24-06-2026
Reference: NZL-WSP-6-XH078.00.0215

Parkburn Quarry - FHLD Parkburn FTAA – Substantive Application

Further to instructions received from Walt Denley (CODC) and Louise Taylor (Taylor Planning) we have now completed an independent review of supplied geotechnical reports associated with a fast track planning application for a residential development of the Parkburn Quarry site in Cromwell.

Figure 2: General site layout - taken from IE report, 2026.

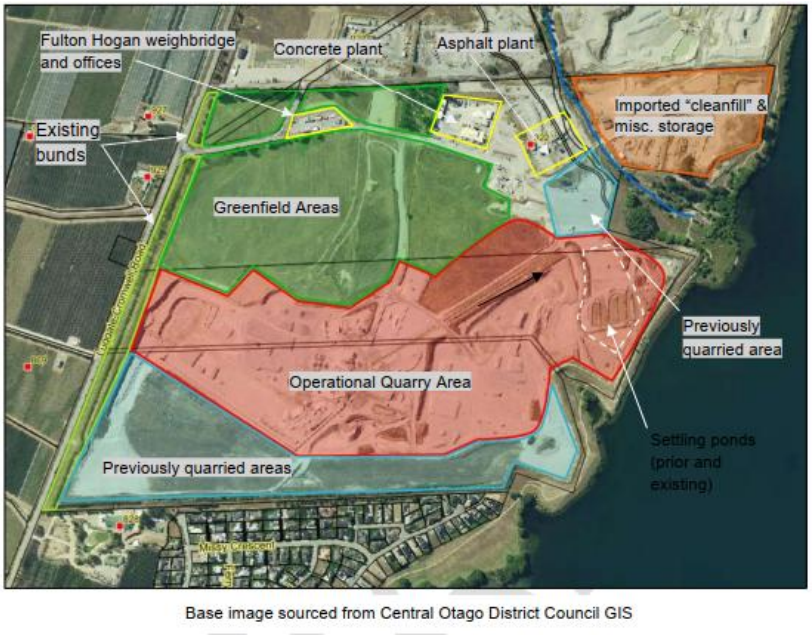
Based on the desk based assessment IE have presented a preliminary ground model for the site and identified three key reclamation areas requiring cut and fill earthworks.

The conclusions reached by IE are that the site requires substantial cut/fill earthworks to facilitate the development level and that filling depths could be of the order of 15m or greater.

In addition to the identified geotechnical challenges it should be noted that the future earthworks and development layout design will need to accommodate potential high wall scenarios at the boundaries of the site area and also between earthworks panels. IE note the requirements for future settlement monitoring of earthworked fill areas prior to permitting development accordingly.
